SUNDRY NOTICES AND REPORTS ON WELLS
Do not use this form for proposals to drill or to re-enter an abandoned well. Use form 3160-3 (APD) for such proposals.

1. Type of Well <input type="checkbox"/> Oil Well <input checked="" type="checkbox"/> Gas Well <input type="checkbox"/> Other		8. Well Name and No. MOBIL 22 FED 1
2. Name of Operator VERNON E FAULCONER INC Contact: KAREN CHARLES E-Mail: kcharles@vefinc.com		9. API Well No. 30-015-21227-00-S1
3a. Address TYLER, TX 75711	3b. Phone No. (include area code) Ph: 903-581-4386 Ext: 233 Fx: 903-581-1515	10. Field and Pool or Exploratory Area S CARLSBAD
4. Location of Well (Footage, Sec., T., R., M., or Survey Description) Sec 25 T23S R26E SENW 1980FNL 1980FWL		11. County or Parish, State EDDY COUNTY, NM

** BLM REVISED **

P&A Procedure for the Mobile Federal #1

CURRENT WELLBORE

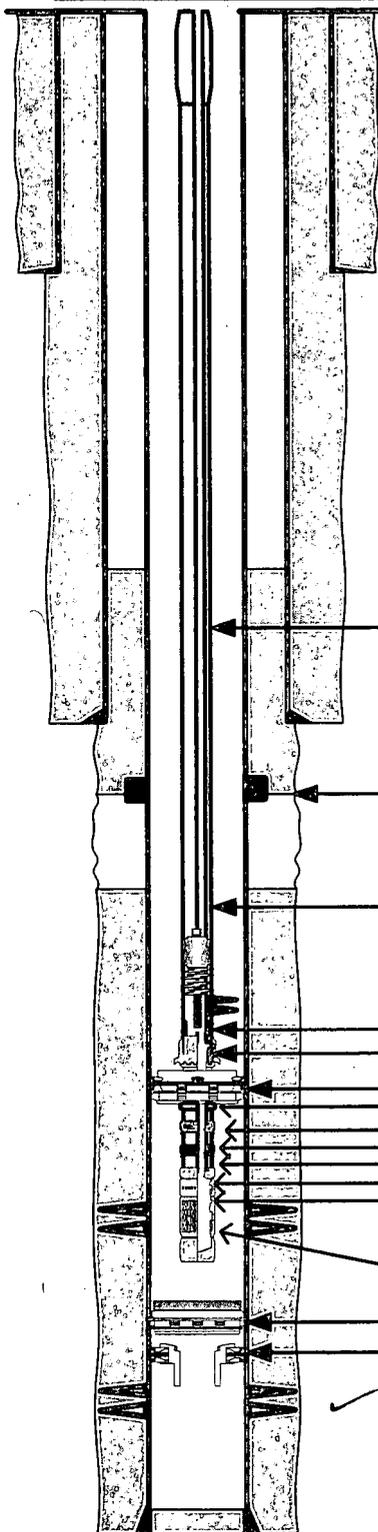
<i>Ashy</i>	<i>990</i>	
<i>T/salt</i>	<i>947</i>	
<i>B/salt</i>	<i>1570</i>	
<i>Del</i>	<i>1935</i>	<i>1938</i>
<i>Cherry</i>	<i>2773</i>	
<i>Bushy</i>	<i>3154</i>	
<i>BS</i>	<i>5270</i>	<i>5254</i>
<i>WC</i>	<i>8617</i>	<i>8664</i>
<i>Cyn</i>	<i>10132</i>	<i>10334</i>
<i>ST</i>	<i>10451</i>	<i>10334</i>
<i>AT</i>	<i>10769</i>	<i>10867</i>
<i>MR</i>	<i>11293</i>	<i>11412</i>

CIBP set @ 11795' w/ 2-1/2" sk cmt on top w/ TOC @ 11,775' *20' cep.*

PROPOSED WELLBORE

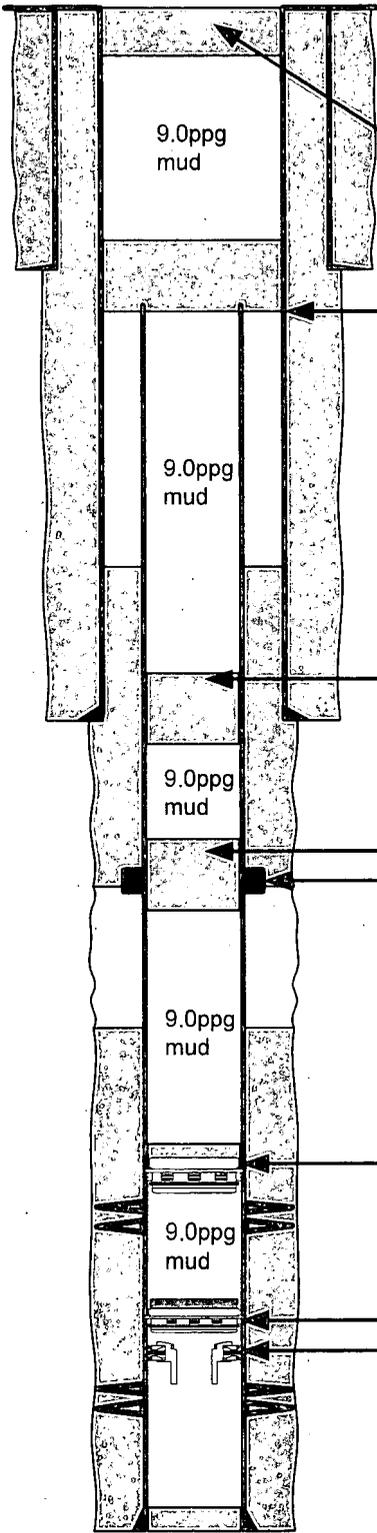
13sxs Class H balanced cmt plug from 33'-3' for surface plug

Cut csg 650' & 47sxs Class H balanced cmt plug from 650'-540' for surface shoe plug

20sxs Class H balanced cmt plug from 5425'-5275'

23sxs Class H balanced cmt plug from 6594'-6424'

CIBP set @ ^{11424 25 5x} 11510' w/ 2-1/2 sxs Class H cmt on top w/ TOC @ ¹¹³⁷² 11490'

1. Kill well with 9.0ppg mud
2. MIRU rig. ND prod tree & NU BOP's.
3. Release packer & POOH w/ tbg & packer BHA
4. RU e-line & RIH w/ CIBP & set CIBP @ 11,510'. *50-100' above upper Perf. 11424.*

5. RIH w/ dump bailer & spot ~~2-1/2~~^{2 1/2} sxs Class H cement on top of CIBP w/ TOC @ 11,490'. *Spot cnt to 11372*
6. RIH w/ tbg to 11,485' and circ wellbore w/ 9.0ppg mud.

7. PU tbg to 6594' and spot balanced ~~23~~²⁵ sxs Class H cement plug at 6594'-6424'. *25 sxs min. 6394 WOC Tag*
8. PU tbg to 5425' and spot balanced ~~20~~²⁰ sxs Class H cement plug at 5425'-5275'. POOH w/ tbg. *25 sxs 5350-5350. Tag.*

9. RU e-line & RIH w/ jet cutter & cut 5-1/2" casing at 650'.
10. POOH w/ cut 5-1/2" casing.
11. RIH w/ tbg to ~~650~~⁷⁰⁰ and spot balanced 47 sxs class H cement plug at ~~650~~⁷⁰⁰-540'. PU tbg to 400'.
WOC Tag 700

12. RIH w/ tbg to 540' & tag cement.
13. PU tbg to ~~33~~⁶⁰ and spot balanced 13 sxs Class H cement plug at ~~33~~⁶⁰-3'. *60' - surf.*
14. Cut off wellhead/all casings 3' below ground level and weld a steel plate over all casings and erect a marker monument. Clear off and restore well location per BLM guidelines.

* Add Plugs. *(25 sxs min. class H.)*
 Spot from 10200 - 10000. (T/canyon)
 Perf/SQZ ~~spot~~ from 8714 - 8514. (T/Wolfcamp)
 WOC Tag,

* Add Plug Perf just above tag @ 5350., SQZ
 cnt (Class C) from 5350 - 5200. WOC Tag

Perf @ 1988, SQZ cnt to 1868. WOC Tag
 (T/Del)

Perf @ 1620, SQZ cnt to 1500. WOC Tag
 (B/Salt)

Perf @ 1000, SQZ cnt to 900. WOC Tag
 (T/Salt)
